Clarification Note - CNPA

Hydroplan submitted a planning application for a small-scale (1.5MW) hydroelectric scheme on the Bruar Water, Blair Atholl to Perth and Kinross Council on 4th January 2012. As the scheme lies within the Cairngorms National Park, the application was referred to the Cairngorms National Park Authority (CNPA) for comment. Following a site visit and initial meeting with Hydroplan on 3rd May 2012, CNPA requested further information and clarification on a number of aspects of the scheme, each of which is addressed below.

Fig. 5-1 Tearnalt Powerhouse

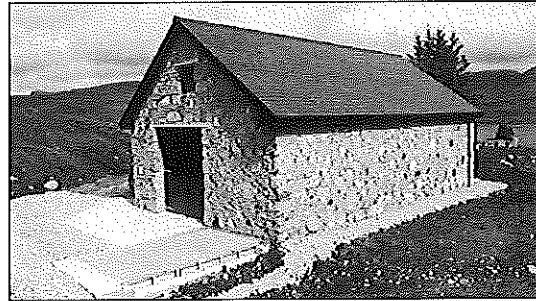
Item 5 – Stone Cladding

The powerhouse will be stone clad on all elevations with a profiled tin roof. Some examples of stone clad powerhouses are shown below in fig. 5-1 and fig. 5-2.

Fig. 6-1 HPPE Pipe Bridge

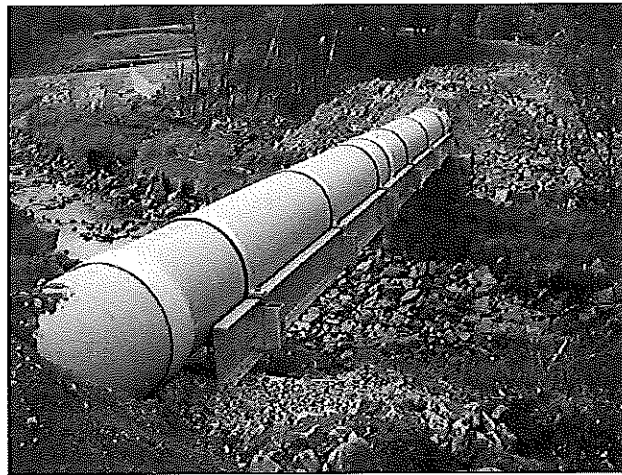
Item 6 – Pipe Bridge

The majority of the pipeline will be buried but there will be an over ground crossing over the Allt a Chaise just before the powerhouse. A concrete thrust block will be required at either end of the pipe bridge to secure the pipe and straps will be used to hold the pipe onto the bridge. Examples of pipe bridges are shown below in fig. 6-1 and fig. 6-2.

Fig. 8-1 Thrust Block

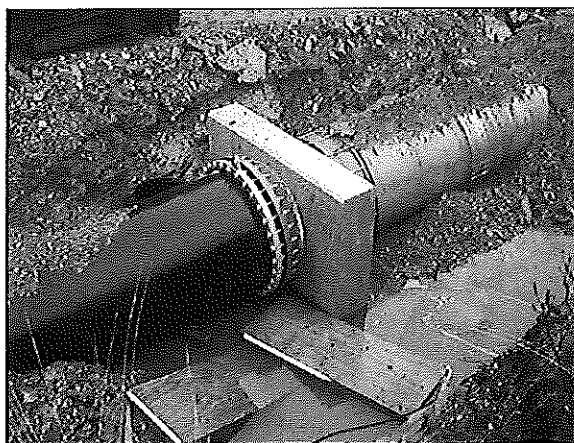
Item 8 – Thrust blocks and air valves

A detailed pipeline long section has not been prepared at this stage but from the topographical survey available it is predicted that two thrust blocks (fig. 8-1) will be required, one at approximately NN 8280 7345 and one at the change in direction above the powerhouse at approximately NN 8238 7283. There will also be a thrust block either side of the pipe bridge. In addition to the thrust blocks, there will also be a small concrete block at the transition between HPPE and GRP pipe (see fig. 8-2). All thrust blocks (apart from the pipe bridge) will be buried.

Fig. 8-3 Air Valve

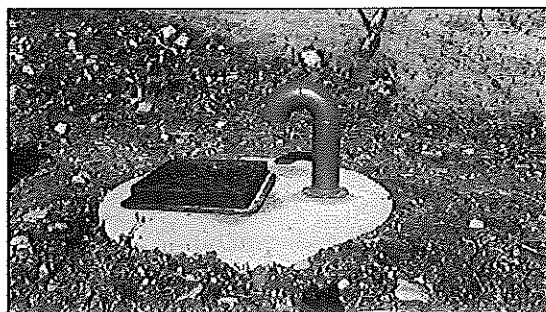
Air valves will be required approximately every kilometre; hence there will be 4-6 in total. They will be adjacent to the track and will be painted green (see figs. 8-3, 8.4).
